Incorrect Labeling Tag, Coolant Connections

The Coolant Outlet tag on some units may be incorrect. See below for proper coolant connections.

Tag Location

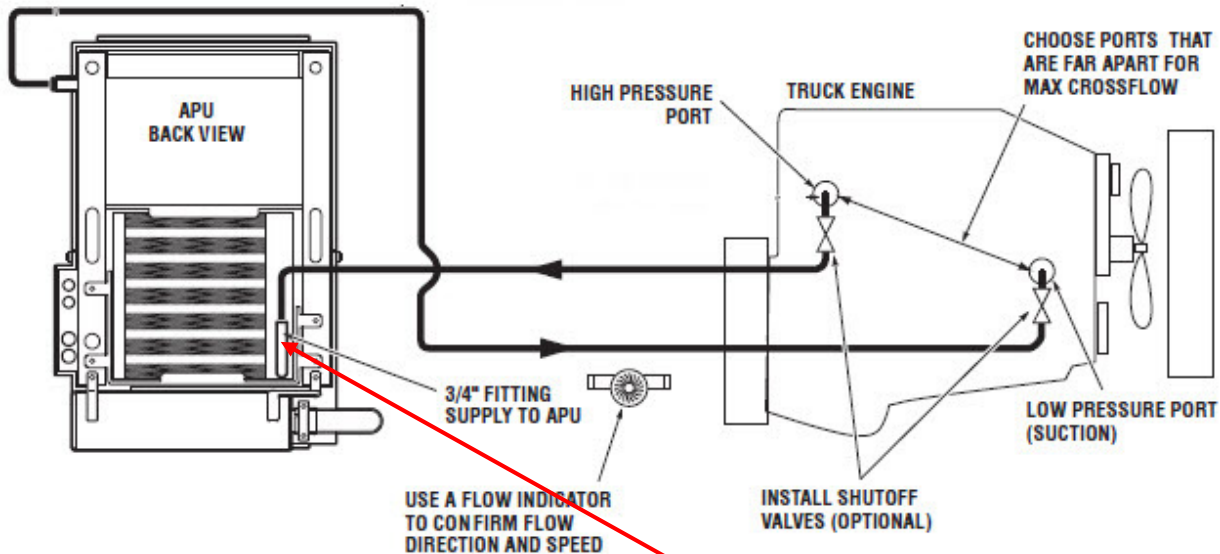
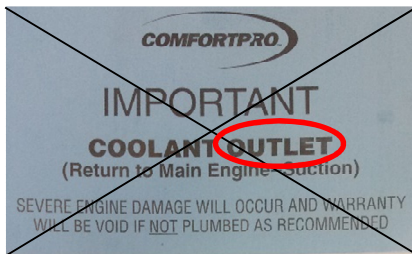
← An **incorrect** label may have been installed on the lower coolant inlet connection to the APU listing it as the outlet

← **Correct** Label. Coolant inlet is the lower connection on the APU and should be connected to the main engine cylinderhead.
